Architectural Review Board Staff Report

Project type: Amended Architectural Elevations

Location: 100 THF Boulevard

Description: Chesterfield Commons, Lot 8 (Walmart): Amended Architectural Elevations for a

Figure 7: Eastern and western elevations

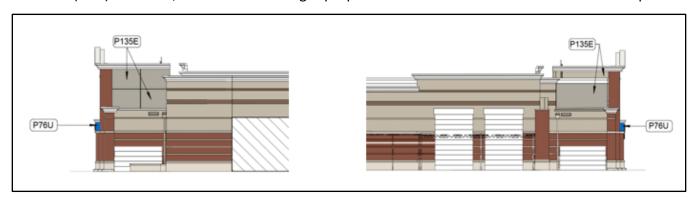
Although the majority of changes occur on the primary northern elevation, there is one change to both the eastern and western elevations. The medium gray from the northern elevation will carry over to the corners of the building to the eastern and western elevations. There are no changes proposed to the southern (rear) elevation, nor are there changes proposed for the auto center or the seasonal shop area.
